630 TYPE TELEPHONE SET
 CIRCUIT LABEL P-11E399
 SCALE NONE

A-579109

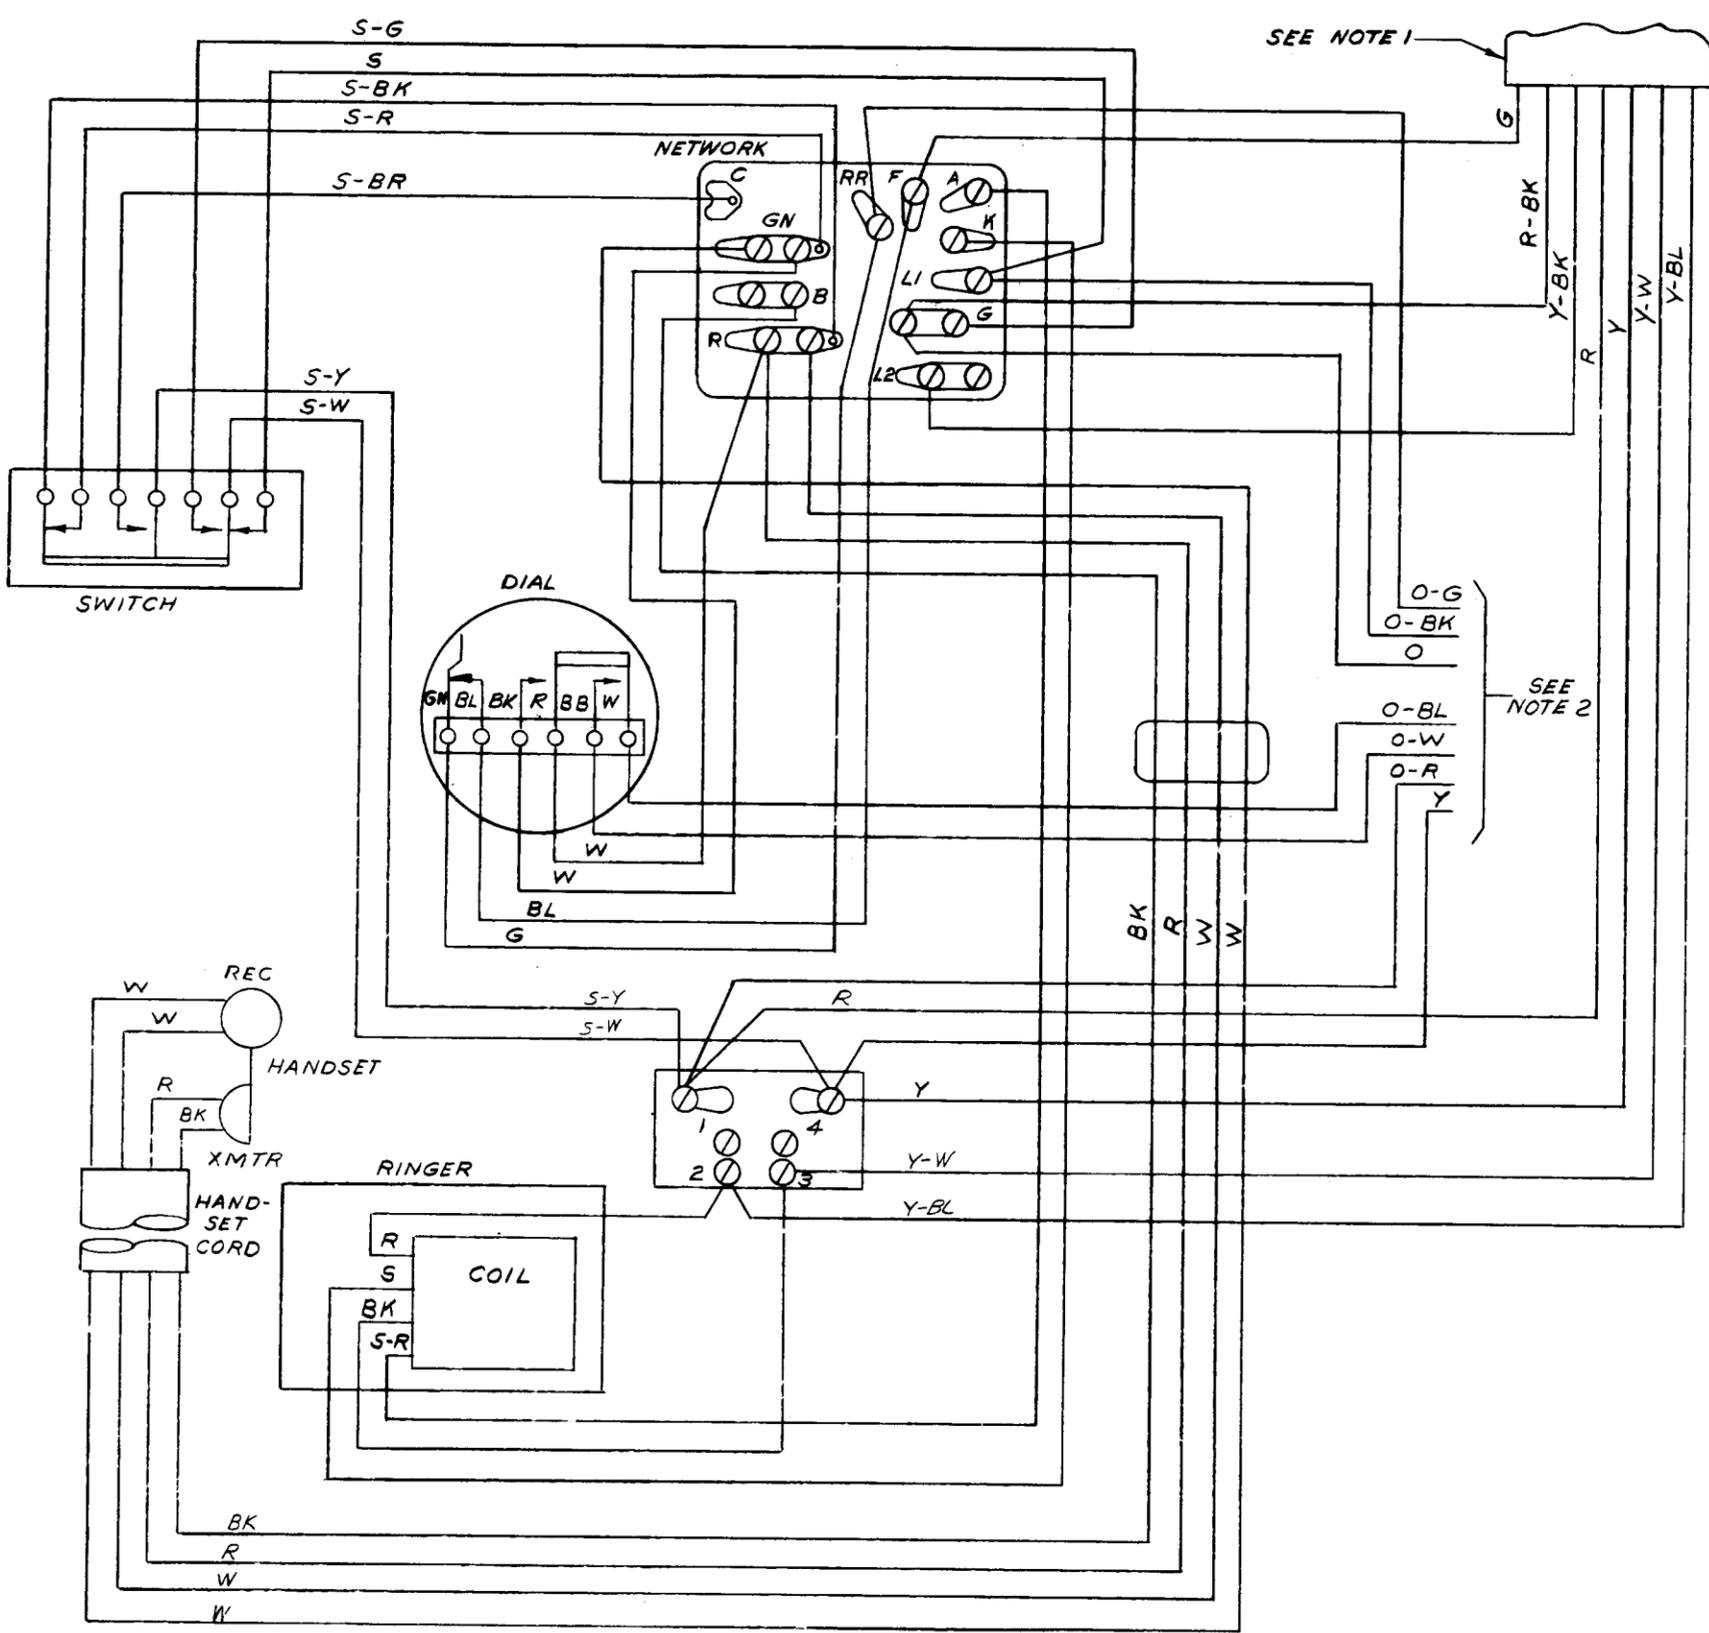
ISSUE-9 8-16-60
 REDRAW DUE TO EXTENSIVE CHANGES (REISSUE FOR 630A1 TEL. SET) TRACING SIZE WAS 35"

ISSUE-10 12-5-60
 MFG INFO WAS SPEC FOR 630AW CODE (553208 D) MFG INFO WAS SPEC FOR 631AW CODE (553211 D)

ISSUE-11 2-21-61
 CHANGED: RINGER LEADS "S" AND "S-R" CONNECTED TO TERMINALS X AND R, RESP. OF THE NETWORK WERE CONNECTED TO TERMINALS A AND K, RESP.; DIAL CONTACTS BK AND R WERE SHOWN REVERSED WITH "W" LEADS FROM DIAL CONTACTS BK AND R TO NETWORK TERMINALS GN AND R, RESP. CHANGED ACCORDINGLY; ISSUE NO. 109, CIRCUIT LABEL, P-11E399, WAS G (442230-B) CHANGED "Y" MTS CO. LEAD WAS BK (442209B)
